Central-West Orana REZ Transmission

RESPONSE TO ENVIRONMENTAL IMPACT STATEMENT SUBMISSION

Primary CO2 producers, now and future projections.

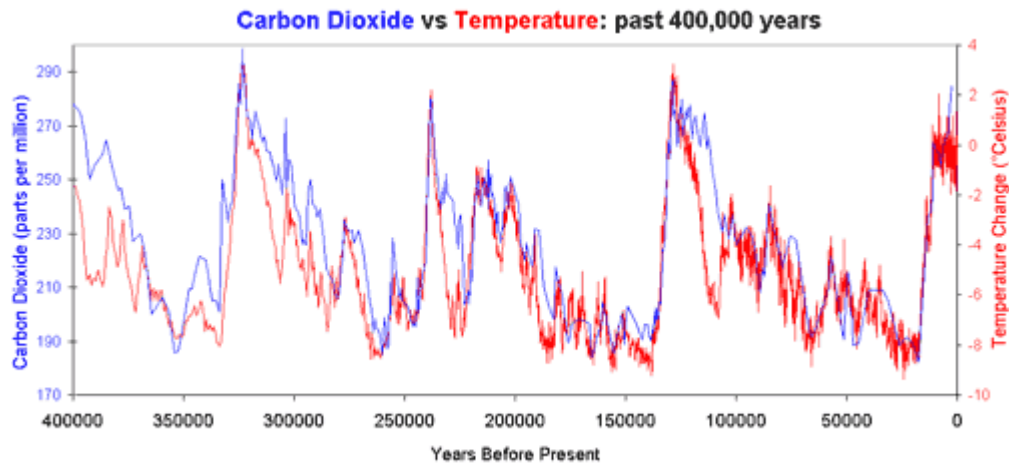
Compared to the major producers of CO2 Australia and New Zealand's contributions are miniscule and even more so when you consider that Australia is penalised for exporting our low emissions coal. Australia could easily reduce its per head contribution to CO2 production by stopping the export of Coal however to do so would see a net worldwide increase in CO2 production because is Australia's black coal is relatively clean when compared to other coals found around the world, especially Chinas. Re-imagine the above graph if Australia stoped exporting coal to China and they had to burn their own coal, remember that China is reputedly currently building some 40-50 new coal fired power plants!
